ECE/TRANS/WP.29/GRE/2010/11
14 January 2010

REGULATION No. 37
(Filament lamps)

Proposal for Supplement 36 to the 03 series of amendments to Regulation No. 37

Sheet H16/1

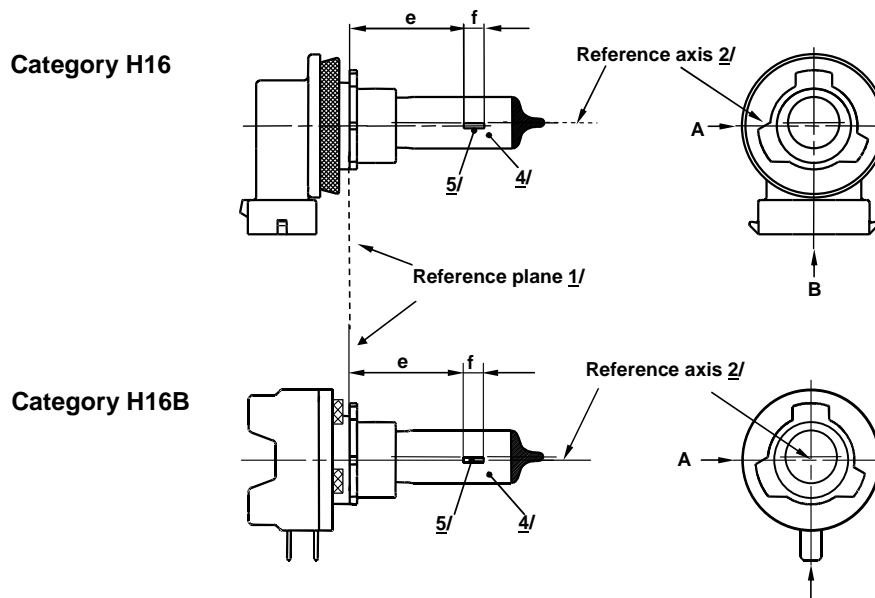
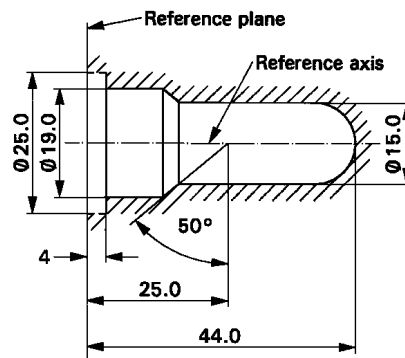
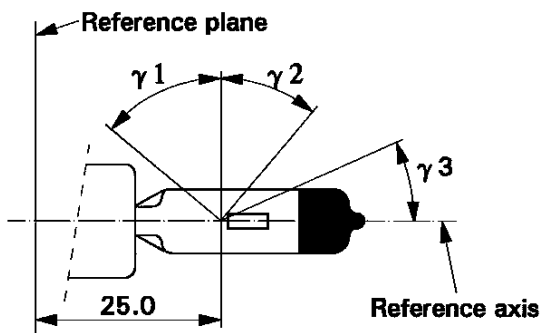
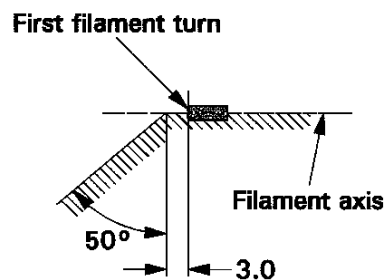
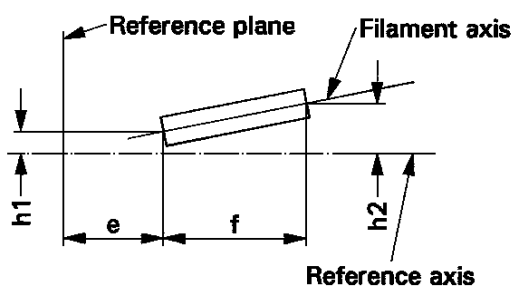
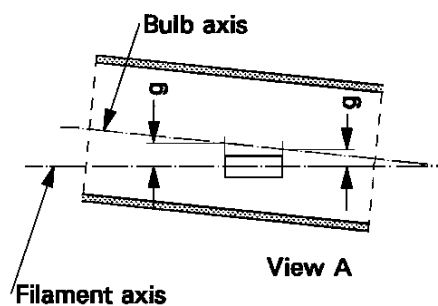
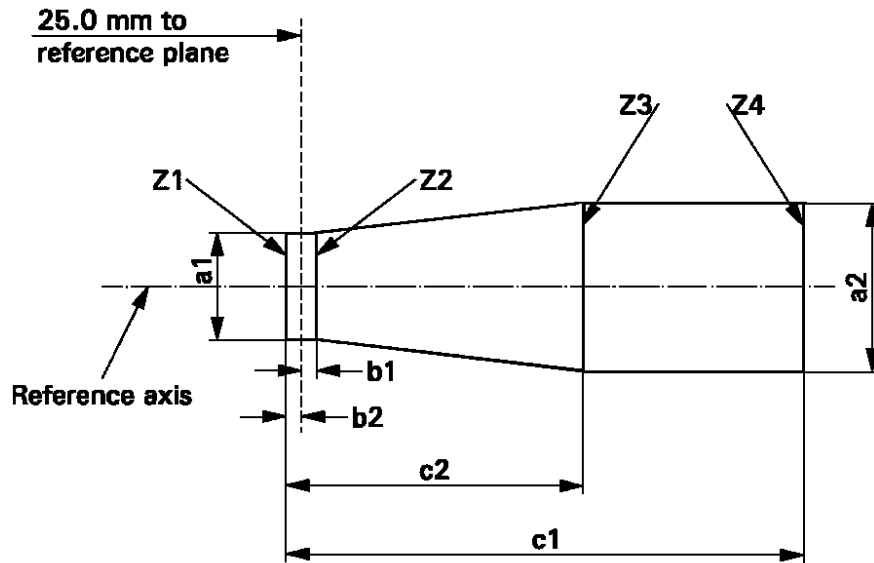
Replace sheets H16/1 to 4 by new pages, to read (see next pages):

CATEGORIES H16 and H16B

Dimensions in mm		Filaments lamps of normal production		Standard filament lamp
		12 V		12 V
e	11/	25.0	12/	25.0 ± 0.1
f	11/	3.2	12/	3.2 ± 0.1
g		0.5 min.		u.c.
h1		0	12/	0 ± 0.1
h2		0	12/	0 ± 0.15
γ1		50° min.		50° min.
γ2		40° min.		40° min.
γ3		30° min.		30° min.
Cap:	H16: PGJ19-3 H16B: PGJY19-3	in accordance with IEC Publication 60061 (sheet 7004-110-2) in accordance with IEC Publication 60061 (sheet 7004-146-1)		
ELECTRICAL AND PHOTOMETRIC CHARACTERISTICS				
Rated values	Volts	12		12
	Watts	19		19
Test voltage	Volts	13.2		13.2
Objective values	Watts	22 max.		22 max.
	Luminous flux	500 +10% / -15 %		
Reference luminous flux: 500 lm at approximately 13.2 V				
Reference luminous flux: 550 lm at approximately 13.5 V
